Access Compliance Report

Public Rights-of-Way (Curb Ramps)

Intersection ID: 43363	Main Street: PROSPERITY_VIEW_DR	Cross Street: RIDGEVIEW_COMMONS_DR	Location:	N
ADA ID: 09B3B7AB025C	Ramp Type: BlendTrans1	Initial Pass/Fail: Pass	Overall Compliance: No	Severity Score: 19

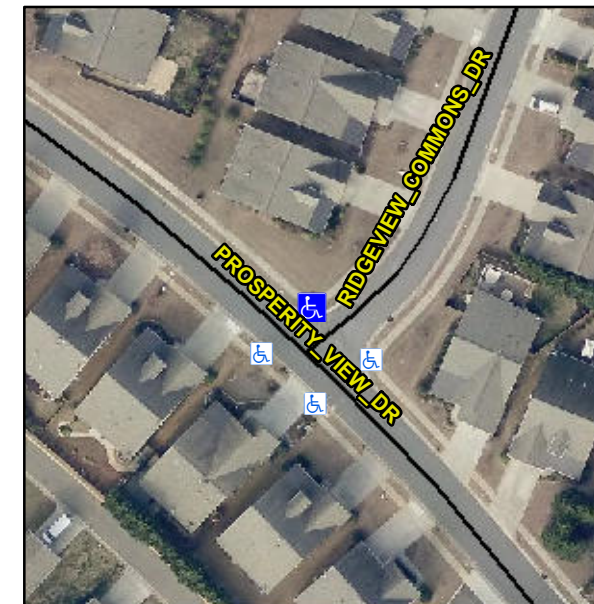
R304.2.1, R304.2.2-Perp, R304.3.2-Para, R305.2, R302.7.2

Compliance	Description	Data	Compliance	Description	Data
N/A	Ramp Length (in)	49.5	Yes	BlendTrans Slope (%)	3.6
Yes	Ramp Width (in)	51.0	Yes	BlendTrans XSlope (%)	0.8
N/A	Flare Type LT	Sloped	N/A	Flare Type RT	Sloped
N/A	Flare Slope LT (%)	5.2	N/A	Flare Slope RT (%)	5.5
N/A	Flare Traversable LT?	No	N/A	Flare Traversable RT?	No
No	Landing Length (in)	37.0	Yes	DWS Provided?	Yes
No	Landing Width (in)	46.0	Yes	DWS Contrast?	Yes
No	Landing Slope (%)	2.7	Yes	DWS Length (in)	24.0
Yes	Landing X Slope (%)	0.9	Yes	DWS Full Width?	Yes
N/A	Landing Curb? (Y/N)	No	No	DWS Offset (in)	2.5
N/A	Shared Landing?	No			
Yes	Gutter Ponding?	No	Yes	Gutter Slope (%)	0.4
No	Gutter Lip Ht (in)	1.0	Yes	Gutter X Slope (%)	0.1
N/A	Painted X Walk1?	No	N/A	Painted X Walk2?	No
	X Walk 1 Direction	To SE		X Walk 2 Direction	To SW
	X Walk 1 Width (in)	N/A		X Walk 2 Width (in)	N/A
	X Walk 1 Slope (%)	3.1		X Walk 2 Slope (%)	1.4
	X Walk 1 X Slope (%)	0.2		X Walk 2 X Slope (%)	0.7

Remove & Replace Curb Ramp With Two New Directional Ramps or Equivalent. Grind Gutter Lip.
